# Access Compliance Report

## Public Rights-of-Way

Intersection ID: 31569	Main Street: ARVIN_DR	Cross Street: CROSS_ST	Location:	E
ADA ID: 0D66D8792839	Ramp Type: Perp	Initial Pass/Fail: Fail	Overall Compliance: No	Severity Score: 10

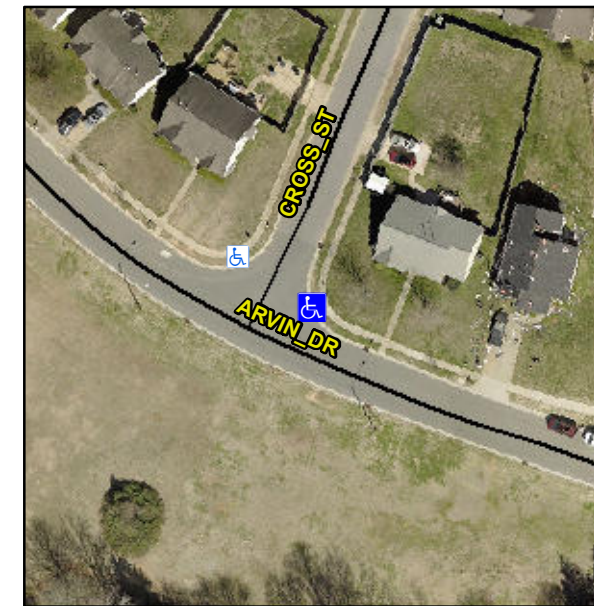
**Not Found, R304.5.1, R304.5.3**

Compliance	Description	Data	Compliance	Description	Data
N/A	Ramp Length (in)	48.0	Yes	Ramp Slope (%)	6.3
No	Ramp Width (in)	39.5	No	Ramp XSlope (%)	3.6
N/A	Flare Type LT	N/A	N/A	Flare Type RT	N/A
N/A	Flare Slope LT (%)	N/A	N/A	Flare Slope RT (%)	N/A
N/A	Flare Traversable LT?	N/A	N/A	Flare Traversable RT?	N/A
N/A	Landing Length (in)	N/A	N/A	DWS Provided?	N/A
N/A	Landing Width (in)	N/A	N/A	DWS Contrast?	N/A
N/A	Landing Slope (%)	N/A	N/A	DWS Length (in)	N/A
N/A	Landing X Slope (%)	N/A	N/A	DWS Full Width?	N/A
N/A	Landing Curb? (Y/N)	N/A	N/A	DWS Offset (in)	N/A
N/A	Shared Landing?	N/A			
N/A	Gutter Ponding?	N/A	N/A	Gutter Slope (%)	N/A
N/A	Gutter Lip Ht (in)	N/A	N/A	Gutter X Slope (%)	N/A
N/A	Painted X Walk1?	No	N/A	Painted X Walk2?	N/A
	X Walk 1 Direction	To NW		X Walk 2 Direction	N/A
N/A	X Walk 1 Width (in)	N/A	N/A	X Walk 2 Width (in)	N/A
	X Walk 1 Slope (%)	4.1		X Walk 2 Slope (%)	N/A
	X Walk 1 X Slope (%)	1.4		X Walk 2 X Slope (%)	N/A

**Remove & Replace Entire Ramp.**
